Sheringham Shoal and Dudgeon Offshore Wind Farm Extension Projects

The Applicant's Comments on the Report on Implications to European Sites

Document Reference: 21.2

| Sheringham Shoal and Dudgeon Offshore Wind Farm Extension Projects Examination submission The Applicant's Comments on the Report on the Implications for European Sites (RIES) | |

Sheringham Shoal and Dudgeon Extension Projects

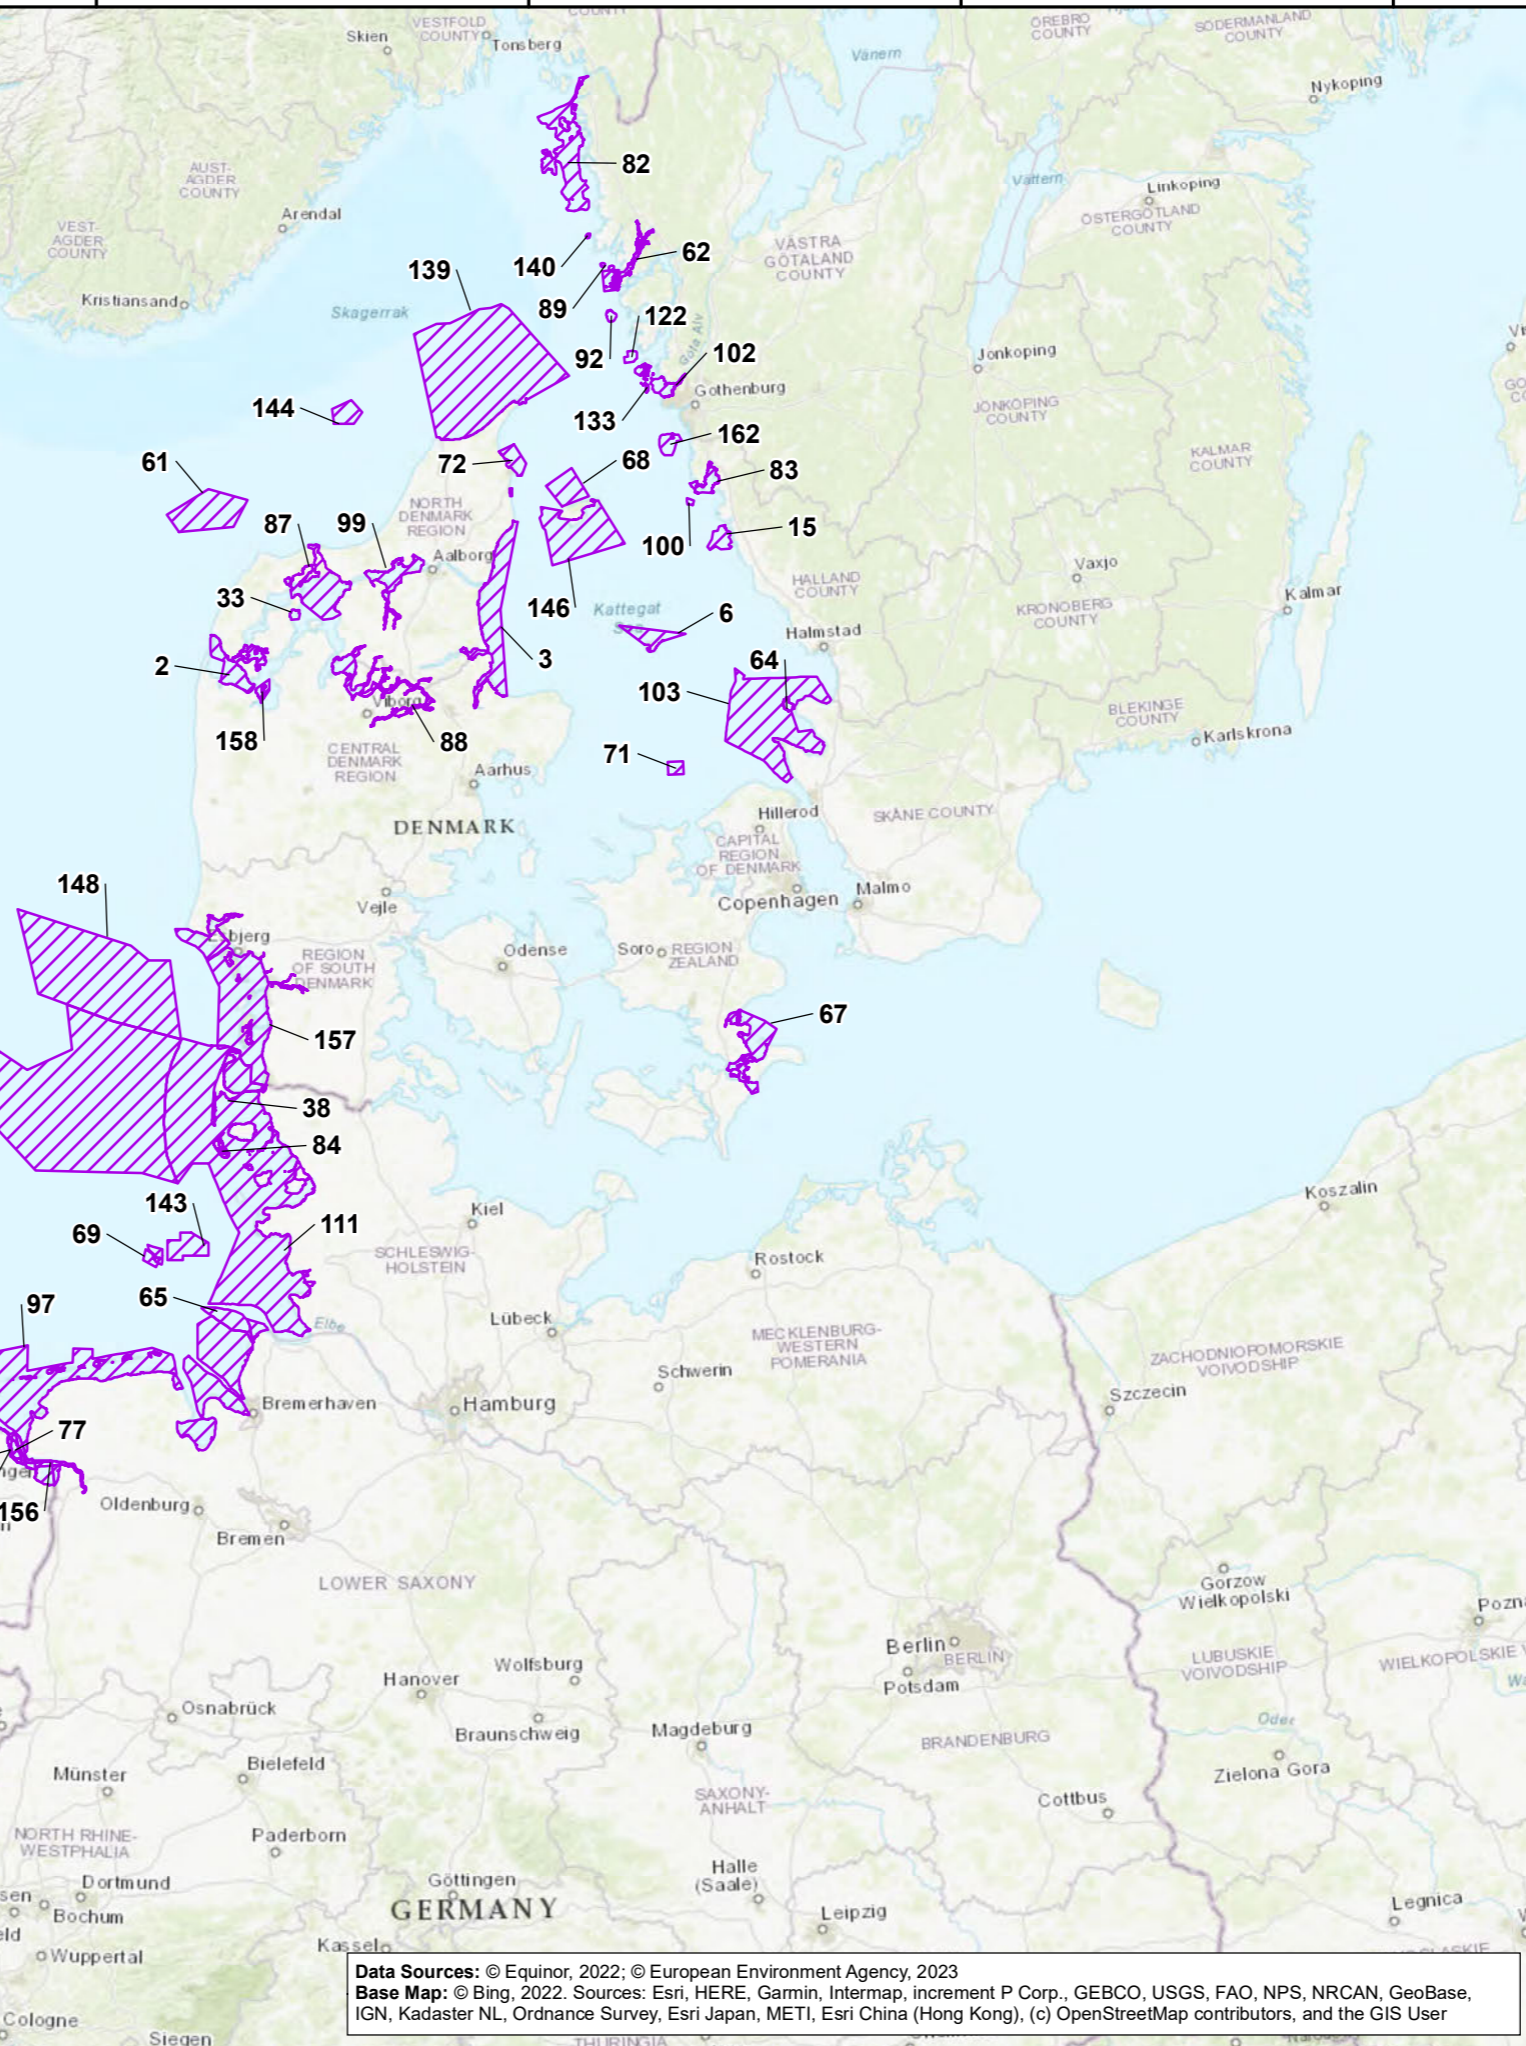
| RIES ID | RIES Question / Extract | Question Addressed to | Applicant Response |
|---------|---|-----------------------|--|
| RIES-Q1 | The Applicant is requested to provide further clearly labelled figures to show the extent of all European sites considered in the Applicant's HRA assessment in relation to the Proposed Developments, including a figure(s) to show non-UK European sites. | The Applicant | <p>These are provided in Annex I.</p> <p>Due to space limitations each figure is provided as follows:</p> <ul style="list-style-type: none"> • UK SPA AND RAMSAR • UK SAC • EUROPEAN SPA AND RAMSAR • EUROPEAN SAC (France) • EUROPEAN SAC (excluding France) <p>It should be noted that the 'SEP and DEP reference' number shown on each figure corresponds to those within Table 3-2 of the Habitats Regulations Assessment Screening Matrices (Revision B) [REP4-009].</p> |
